# **AGENDA**

## **Traffic Committee Meeting**

**8 October 2019**

**PROPOSED PERMISSIBLE PARKING & GUIDE SIGN FOR PERMISSIBLE RESIDENTS' PARKINGS IN NARROW RESIDENTIAL STREETS IN WARRAGAMBA**

**2. Street view of Third Street with Permissible Parking Sign Concept**

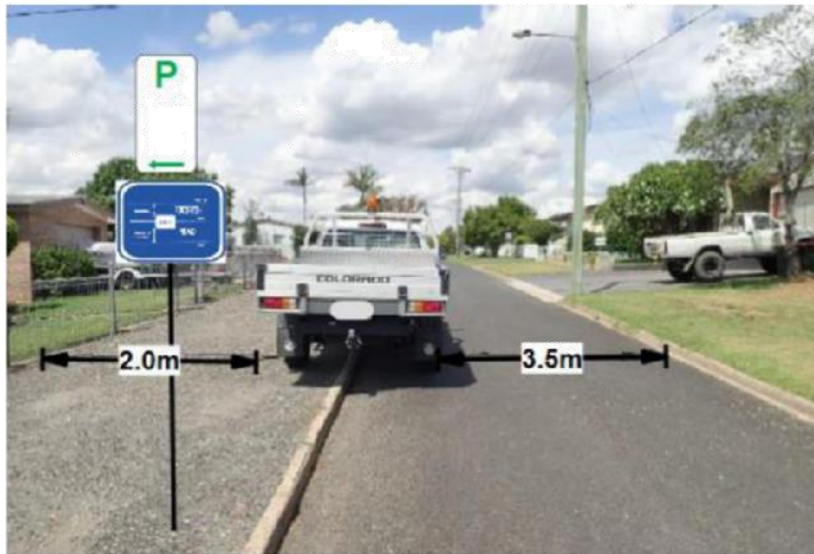
"In principal this should work.

Some issues:

Positive:

- 3.5 mts is wide enough for fire appliance

Potential negative:

- There is not enough room for both property owners (across street) to both park (property too narrow) – can see this happening and then there would not be 3.5 mt left (also neighbours disharmony as would turn into who gets there first to park)
- Allowance for wide mirrors/ opening doors etc.
- Larger vehicles or Truck parking
- If fire vehicle goes down street and needs to back out for whatever reason – this could be very difficult with vehicles parked on both sides of road at various intervals
- Congestion if more than one fire vehicle needs access

Further comment – the chosen streets are the 'widest' in Warragamba and if trial is successful other streets may create problem due to narrow sections and corners which are tight. Perhaps consider reducing the pedestrian access width and allowing vehicles to park closer to fence boundary – but this may be a law requirement. Also the sign is really very confusing – had to really look at it to work out what was meant, locals will eventually work it out, but may prove difficult for visitors to area

"I have no objections with the proposed provided the sight distances are not diminished as outlined by Steve Grady. We will need some resolution on this point."

"This project will not impact on Busways services however, I am slightly concerned in relation to permitting vehicles to park on footpath verges, especially near bus stops. The line of sight is crucial for not only passengers and bus drivers to see the bus approaching, or the passenger waiting at the stop, but also where young passengers such as school students are concerned.

I do believe that there needs to be a certain distance around bus stops, to be considered as a 'NO GO' area to provide a good clear line of sight for safety reasons."
